P00-110 - 15<sup>th</sup> and Broadway Walgreens

- REQUEST:
- A. Negative Declaration
  - B. Special Permit to allow a 24 hour drive thru window for a pharmacy
  - C. Variance to reduce the front yard setback from 5 feet to 0 feet.
  - D. Variance to reduce the street side yard setback from 5 feet to 0 feet.
  - E. Variance reduce the stacking distance for a pharmacy drive-thru from 180 feet to 100 feet.
  - F. Variance to locate an off-site sign in the General Commercial (C-2) zone.
  - G. Lot Line Adjustment to relocate a common property line between two parcels.
  - H. Appeal of the Decision of the Design Review/Preservation Board

LOCATION: 1401 and 1429 Broadway  
APN: 009-0254-005 & 008  
Central City Community Plan Area  
Council District 4

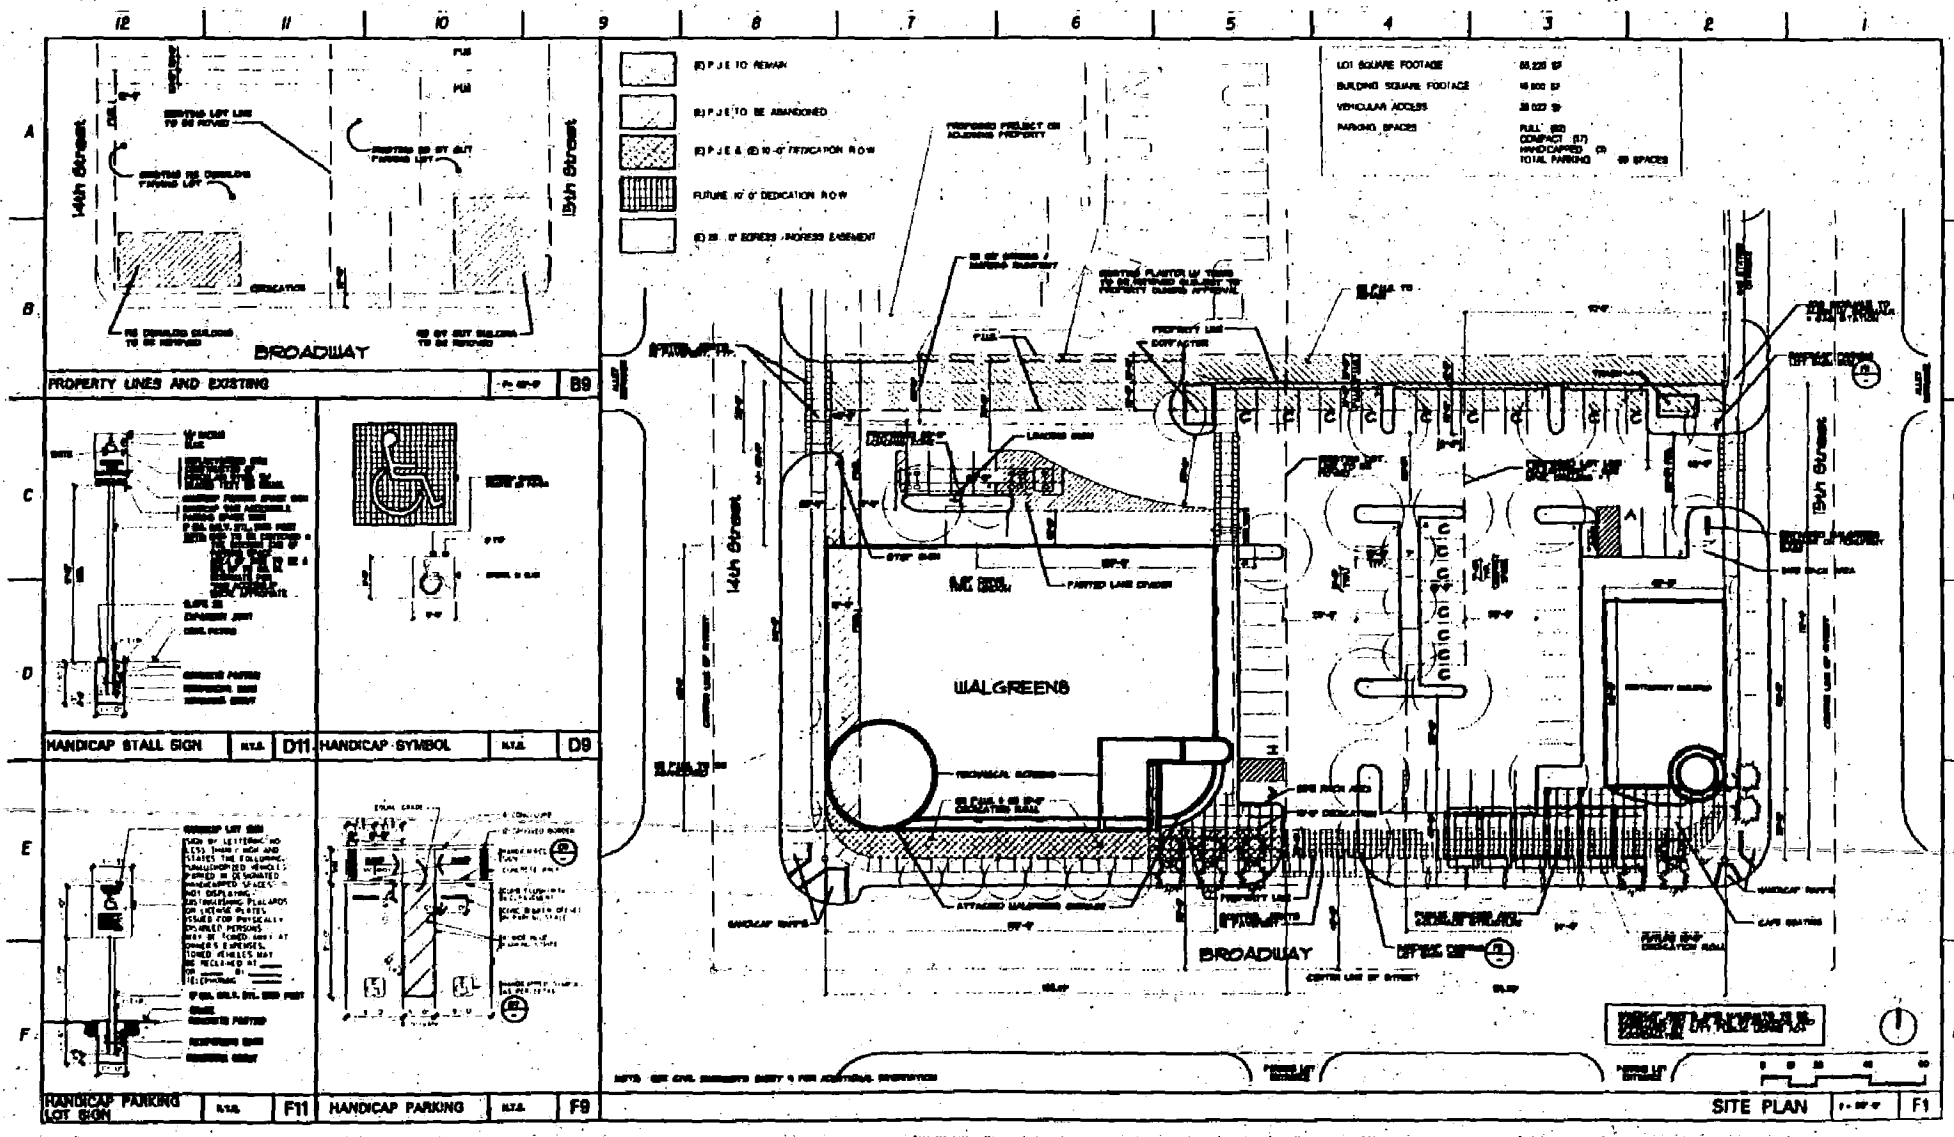
The Design Review and Preservation Board, the City's authority on the subject, took strong exception to the staff's evaluation that the project conformed to the Central City Guidelines and conditioned their approval by a major change in the project layout, which is not included in the project description.

*The Design Review Board condition of approval specified that the site plan be "reversed" to locate the Walgreens's on 15<sup>th</sup> Street and the restaurant on 14<sup>th</sup> Street, to provide more building mass on 15<sup>th</sup> Street. This condition is not evidence that the Board took "strong exception" to staff's evaluation that the project conformed to the Central City guidelines, but rather that they viewed this as a preferable alternative. The applicant is appealing this decision, therefore, the reversed site plan is not a part of the proposed project description.*

WALGREENS BUILDING NORTH ELEVATION

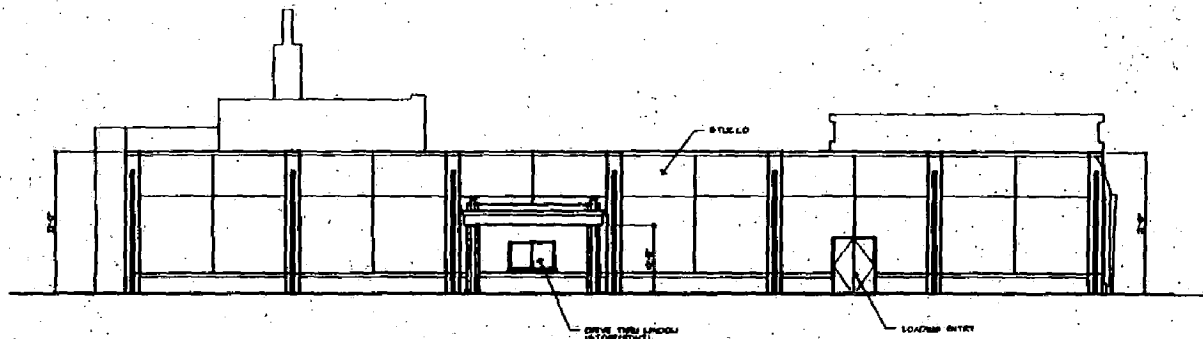
The north elevation needs to be both active and more interesting since it is the main entrance to the Tower District. Currently the building looks like a blank wall. Landscaping and more detail should be added.

Add irrigated landscaping next to the building's north elevation to soften the building.
